TECHNICAL NOTE TN03

RESPONSE TO NEWPORT CITY COUNCIL CONSULTATION COMMENTS

Project:	Proposed Discount Food Store Development
Application Ref:	24/0782
Location:	Queen’s Way, Glan Llyn, Newport
Author:	Ryan Leach
Approved by:	Jim Budd
Ref:	SCP/240426/TN03 Rev 001
Date:	16 December 2024

drawing title
**Proposed Setting Out
Masterplan**

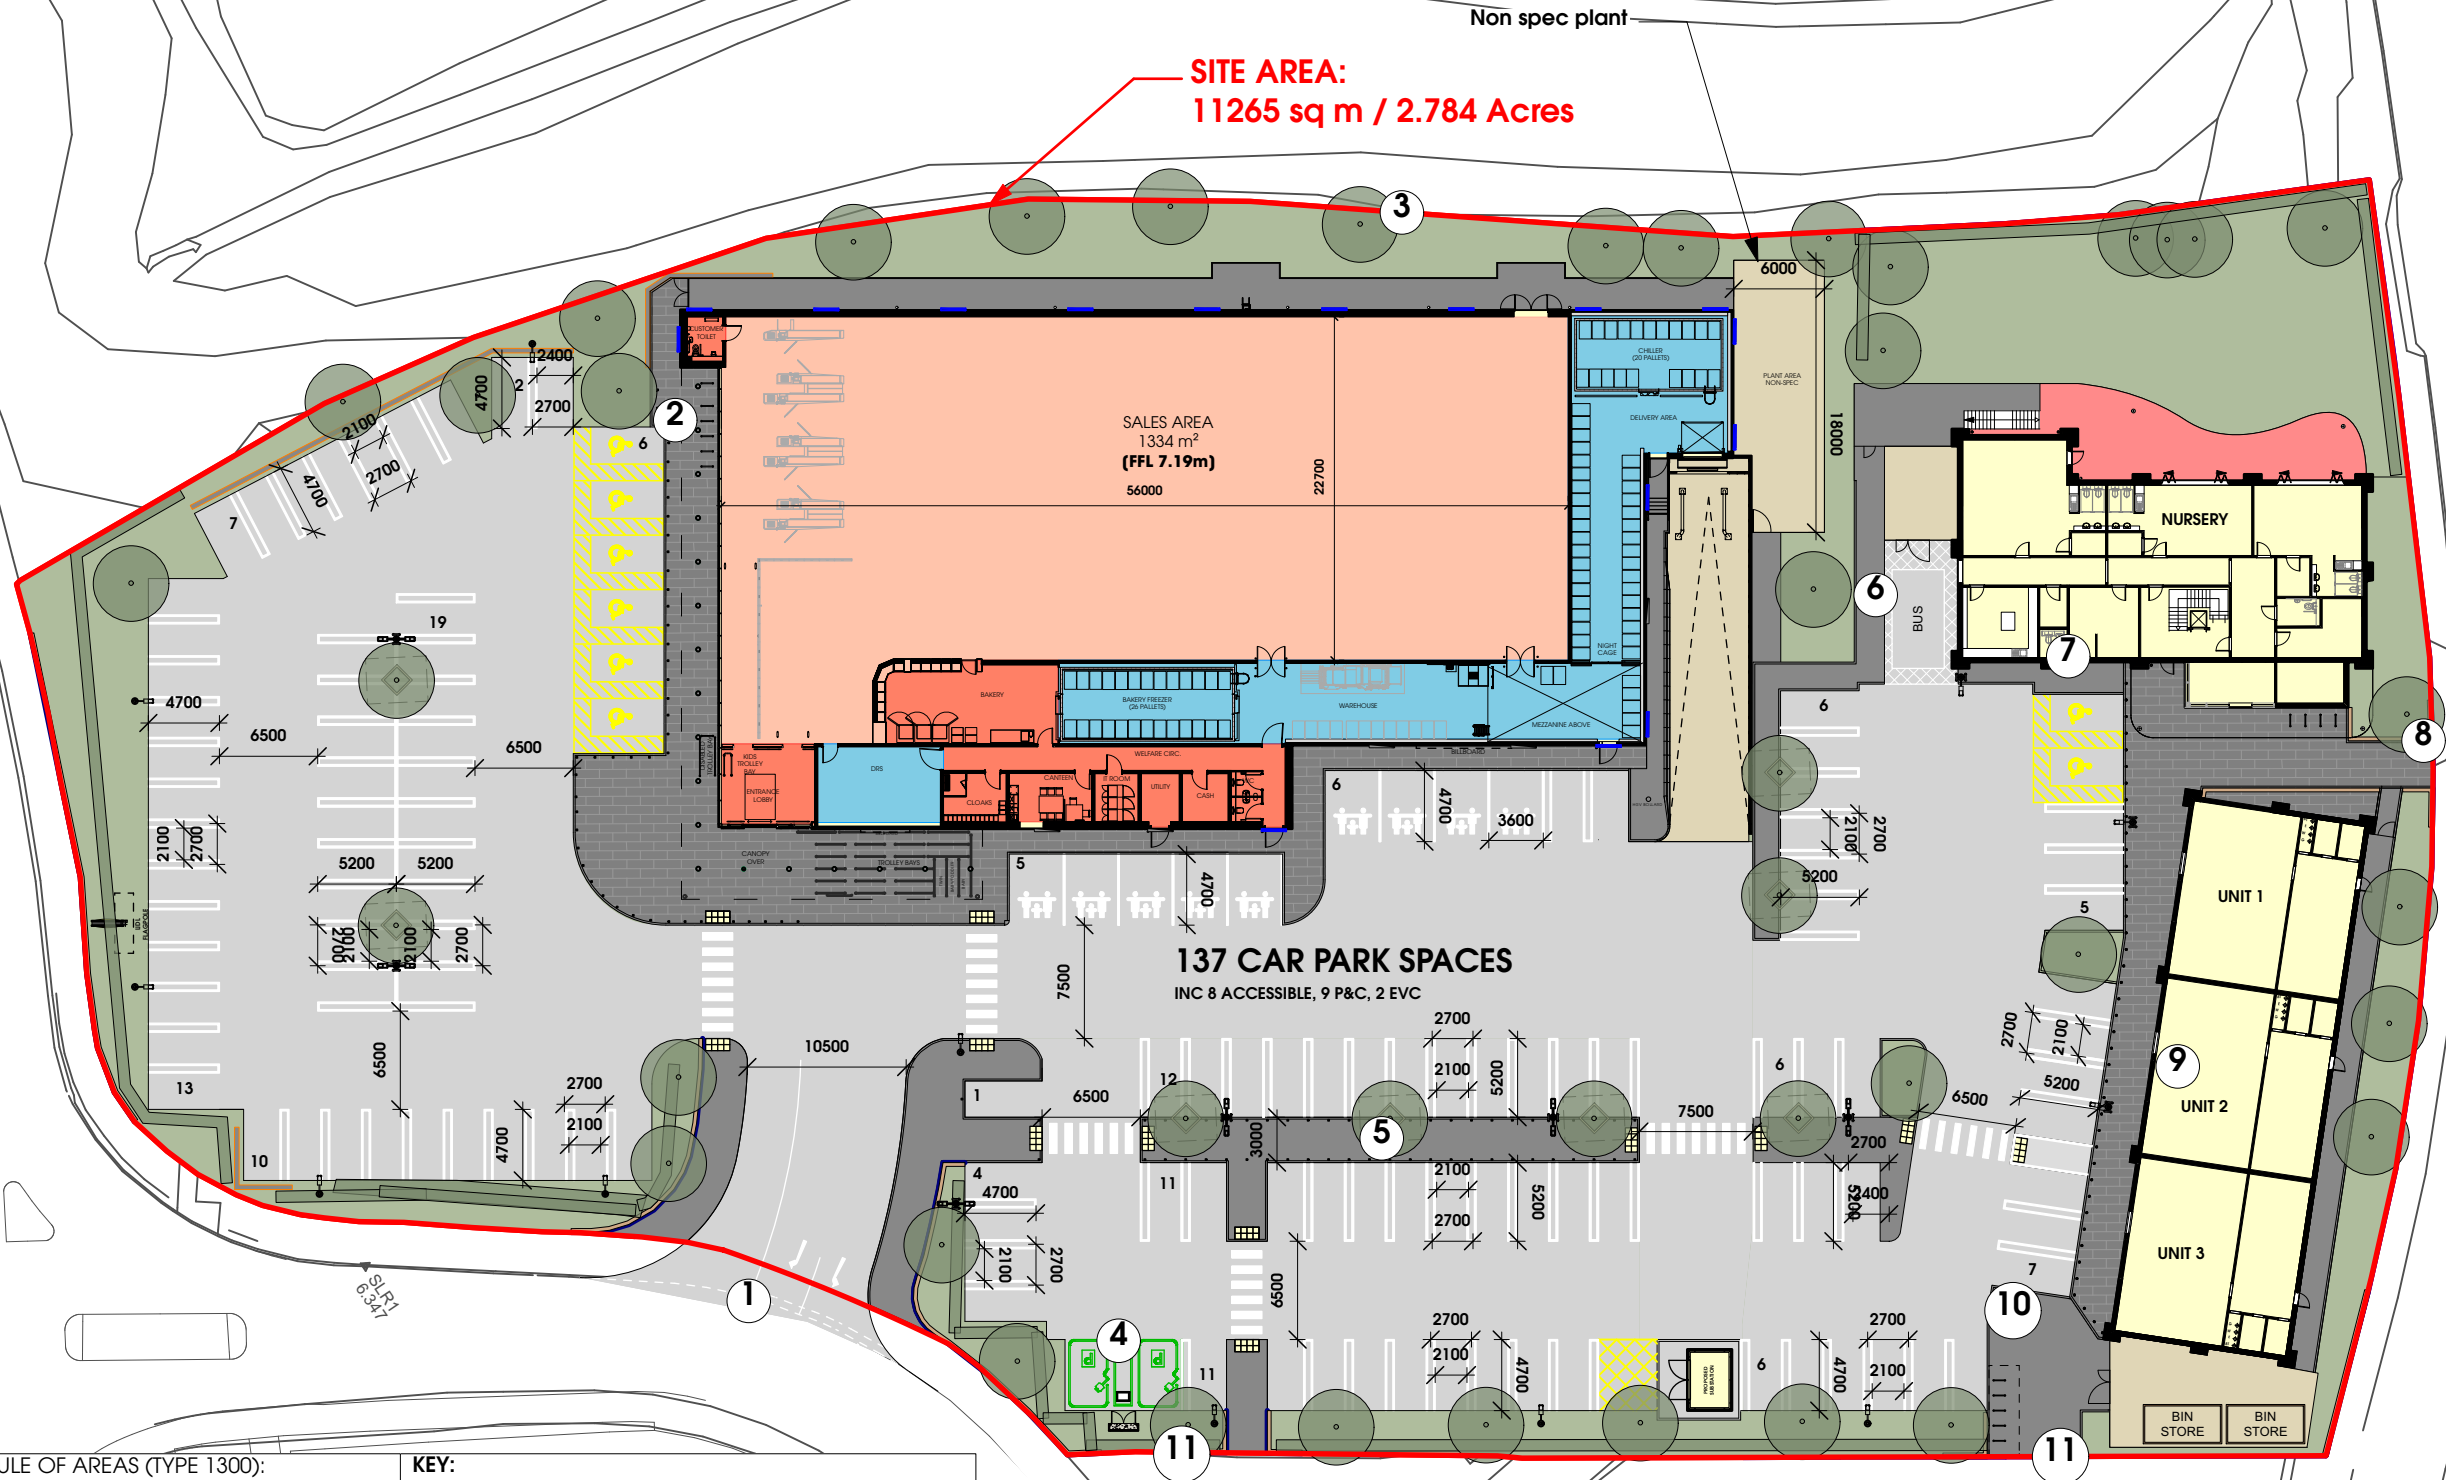
2.	There does not appear to be any consideration of how the site relates to the adjacent site	The latest masterplan, attached as Appendix A to this note, outlines additional pedestrian routes which connect the site to the neighbouring local centre and Bessmer Drive. An

which would be pedestrianised (but with cycle and emergency access). Therefore, the key link to Bessemer Drive (and an extensive residential catchment) does not appear to be considered. These pedestrians/cyclists would either have a longer diversion to enter the site or enter adjacent to commercial units, with little/no provision and no clear routes across the site to the Lidl.	Additional pedestrian route has been introduced east-west across the car park to the north of the site access bellmouth to tie into the wider local centre. Pedestrian access will also be provided from Bessemer Drive and to the north of the cycle parking proposed for the commercial units. Internally, pedestrians will be able to cross the car park and access each unit via dedicated and safe pedestrian routes provided by zebra crossings and tactile paving.

drawing title
Cycle Stands Location and
Schedule

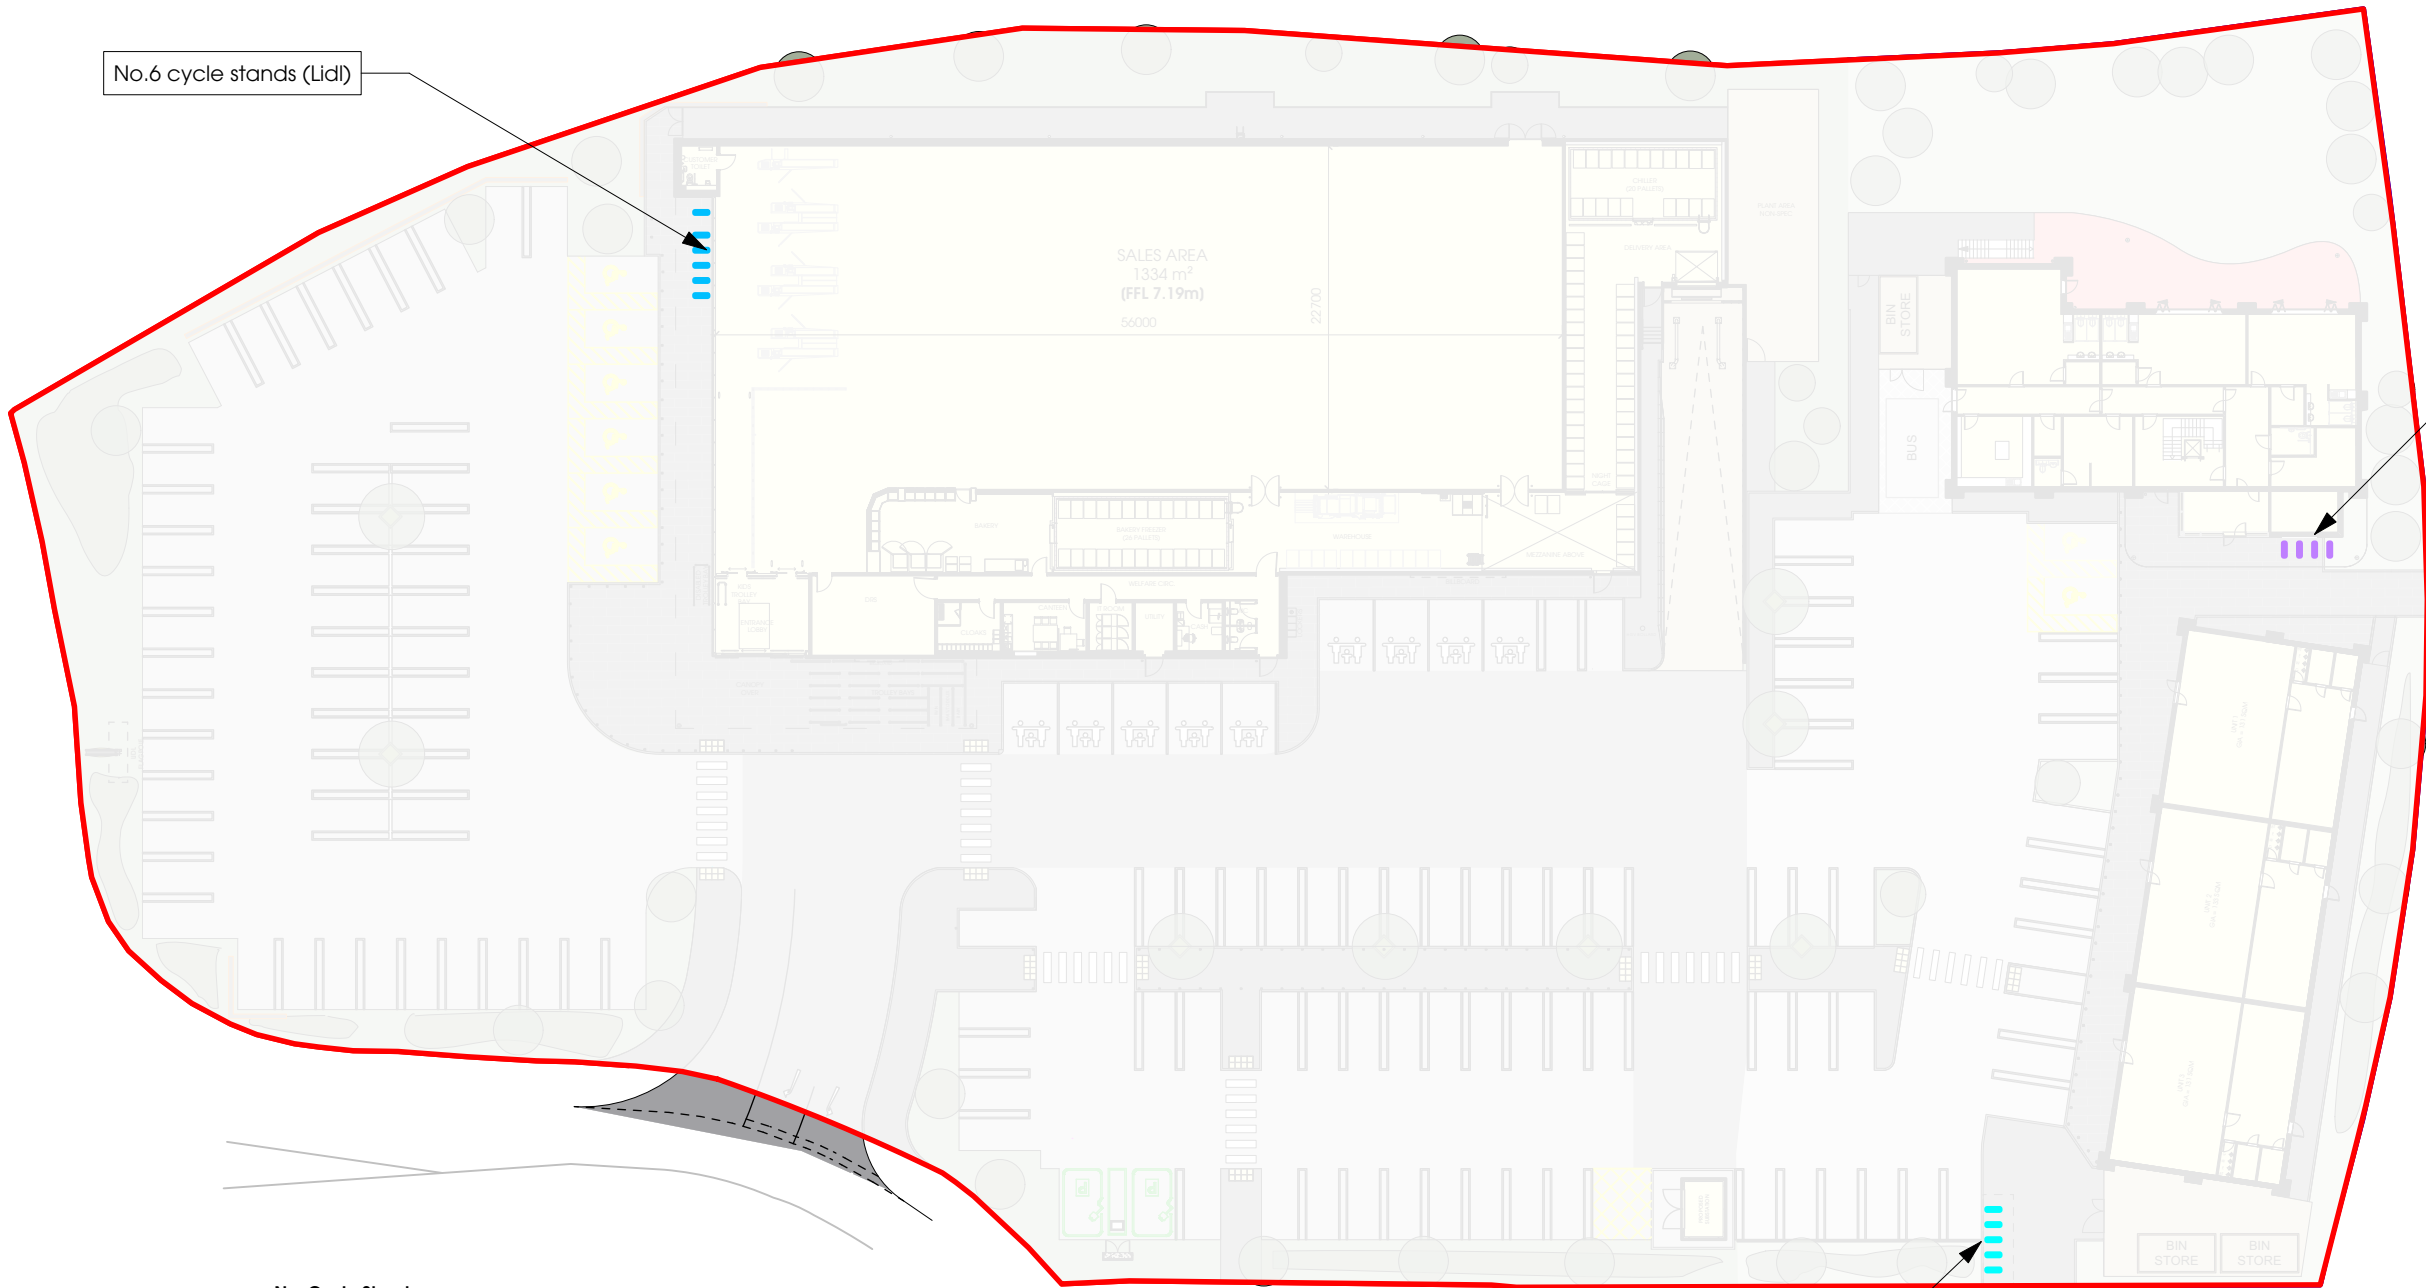
Cycle Parking		
4.	<i>In terms of cycle parking, there is insufficient provision proposed. Long stay cycle parking is needed for all employment uses. None is proposed for the nursery or commercial units, which only have external, less secure, uncovered facilities; and the proposal for the retail element is 'space in the warehouse'. This is not sufficient and dedicated, weatherproof, secure cycle parking is needed for all units. This could be secured by way of condition.</i>	All cycle parking proposed will be covered. The drawing attached as Appendix B to this note illustrates the cycle stands' location and schedule for each use class. Cycle parking for the food store and nursery will be secure, lit and covered by the external canopies. Long stay cycle parking for employees (of which there are circa 8-10 on site at any one time) of Lidl is permitted within the warehouse. Precise details of this arrangement can be secured via condition. Cycle parking for the commercial units will be covered by an external cycle cover.
